APPLICATION NO.	FILING DATE	FIRST NAMED INVENTOR	ATTORNEY DOCKET NO.	CONFIRMATION NO.
10/567,173	02/03/2006	Joseph M. Amato	US03 0199 US2	9635
65913	7550	10/28/2008		
NXP, B.V. NXP INTELLECTUAL PROPERTY DEPARTMENT M/S41-SJ 1109 MCKAY DRIVE SAN JOSE, CA 95131				
EXAMINER				
LEE, HSIEN MING				
ART UNIT		PAPER NUMBER		
2823				
NOTIFICATION DATE		DELIVERY MODE		
10/28/2008		ELECTRONIC

Office Action Summary

10/567,173

FIG. 5A

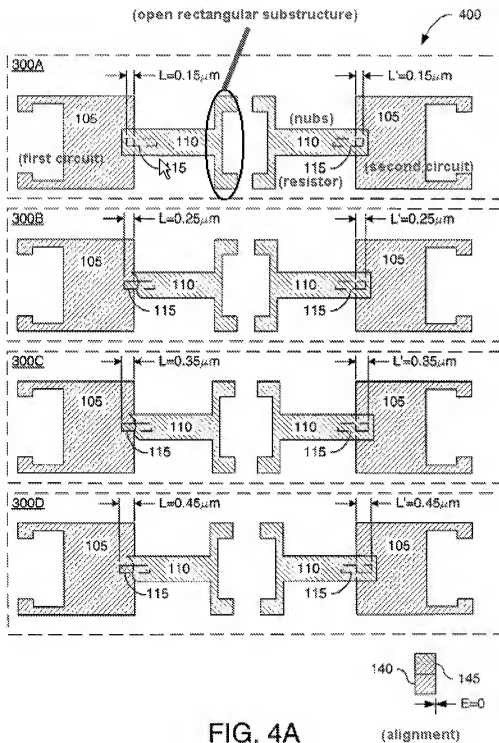
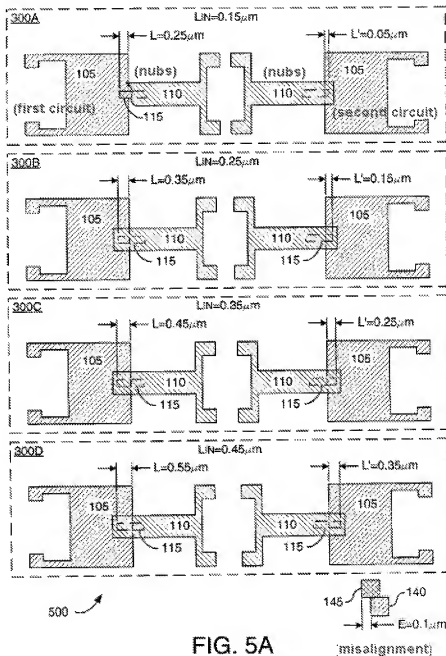
3. Claims 1, 14 and 19 are rejected under 35 U.S.C. 102(e) as being anticipated by Look et al. (US 2001/0049881, submitted by applicant).

In re claim 1, Look et al, in Figs. 4A, 5A and corresponding text, teach a method for identifying misalignments in an overlapping region of a stitched circuit in an integrated circuit fabrication process, comprising:

- creating a first circuit 105 (the one the left) using a reference mask, wherein first circuit 105 includes a first part of an offset dependent resistor structure 115 in the overlapping region (Fig.4A);

- creating a second circuit 105 (the one on the right) using a secondary mask, wherein the second circuit 105 includes a second part of the offset dependent resistor structure 115 in the overlapping region, wherein the offset dependent resistor structure 115 includes a plurality of nubs 110 that interconnect the first part and the second part of the offset dependent resistor structure 115 (Fig.4A);
- measuring a resistance across the offset dependent resistor structure (paragraph [0045]); and
- determining an amount of misalignment based on the measured resistance (paragraphs [0043], [0045], [0055], [0056]).

In re claim 14, Look et al. teach an offset dependent resistor structure for identifying a misalignment in an overlapping region of a stitched portion of an integrated circuit, comprising:

- * a first part of an offset dependent resistor structure 115 (i.e. the one on the left) created in the overlapping region using a reference mask (Figs. 4A and 5A);
- * a second part of the offset dependent resistor structure 115 (i.e. the one on the right) superimposed on the first part in the overlapping region using a secondary mask; and a plurality of nubs 110 that interconnect the first part and the second part of the offset dependent resistor structure 115 to form a single electrical pathway (Figs. 4A and 5A), wherein the resistance of the single electrical pathway is dependent upon the length of the nubs 110 that interconnect the first part and the second part of the offset dependent resistor structure 115 (see Fig.4B and 5B).

In re claim 19, Look et al., in Figs. 4A and 5A and corresponding text, a system for measuring misalignments in an overlapping region of a stitched portion of an integrated circuit, comprise:

- * an offset dependent resistor structure 115, including: a first part 105 (the one on the left) created in the overlapping region using a reference mask, a second part 105 (the one on the right) superimposed on the first part in the overlapping region and created using a secondary mask; and
- * a plurality of nubs 110 oriented in a first uniform direction that interconnect the first part and the second part to form a single electrical pathway, wherein the resistance

of the single electrical pathway is dependent upon the length of the hubs 110 (see Figs. 4B and 5B) that interconnect the first part and the second part, and a system for measuring the resistance across the single electrical pathway (paragraphs [0043], [0045], [0055], [0056].

FIG. 7

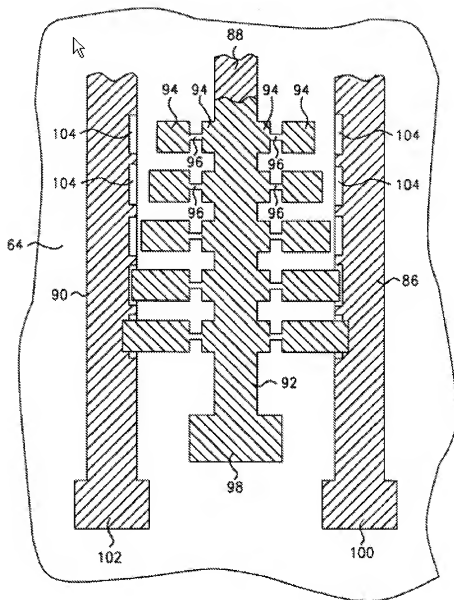
4. Claims 1, 14, 15, 19 and 20 are rejected under 35 U.S.C. 102(e) as being anticipated by Wu et al. (US 6,323,097, submitted by applicant).

In re claim 1, Wu et al, in Fig. 7 and corresponding text, teach a method for identifying misalignments in an overlapping region of a stitched circuit in an integrated circuit fabrication process, comprising:

- creating a first circuit 90 using a reference mask, wherein first circuit 90 includes a first part of an offset dependent resistor structure 96 in the overlapping region;
- creating a second circuit 86 using a secondary mask, wherein the second circuit 86 includes a second part of the offset dependent resistor structure 96 in the overlapping region, wherein the offset dependent resistor structure 96 includes a plurality of nubs 96 that interconnect the first part and the second part of the offset dependent resistor structure 96;
- measuring a resistance across the offset dependent resistor structure (col. 6, lines 33-57); and

- determining an amount of misalignment based on the measured resistance (col. 6, line 65 through col. 7, line 2).

In re claim 14, Wu et al., in Fig.7 and corresponding text, teach an offset dependent resistor structure for identifying a misalignment in an overlapping region of a stitched portion of an integrated circuit, comprising:

- * a first part of an offset dependent resistor structure (94/96 on the left side of 92) created in the overlapping region using a reference mask;
- * a second part of the offset dependent resistor structure (94/96 on the right side of 92) superimposed on the first part in the overlapping region using a secondary mask; and a plurality of nubs 96 that interconnect the first part and the second part of the offset dependent resistor structure 94/94 to form a single electrical pathway, wherein the resistance of the single electrical pathway is dependent upon the length of the nubs 96 that interconnect the first part and the second part of the offset dependent resistor structure 94/96.

In re claim 15, Wu et al., in Fig.7 and corresponding text, teach comprising a pair of test pads 100 and 102 at ends of the single electrical pathway.

In re claim 19, Wu et al., in Fig. 7 and corresponding text, a system for measuring misalignments in an overlapping region of a stitched portion of an integrated circuit, comprise:

- * an offset dependent resistor structure, including: a first part 102 created in the overlapping region using a reference mask, a second part 100 superimposed on the first part in the overlapping region and created using a secondary mask; and
- * a plurality of nubs 96 oriented in a first uniform direction that interconnect the first part 102 and the second part 100 to form a single electrical pathway, wherein the resistance of the single electrical pathway is dependent upon the length of the hubs 96 that interconnect the first part 102 and the second part 100, and a system for measuring the resistance across the single electrical pathway (col. 6, lines 33-57 and col. 6, line 65 through col. 7, line 2).

In re claim 20, Wu et al., in Fig.7 and corresponding text, teach that the system for measuring the resistance comprises a pair of test pads 100 and 102 at ends of the single electrical pathway and a pair of probes.
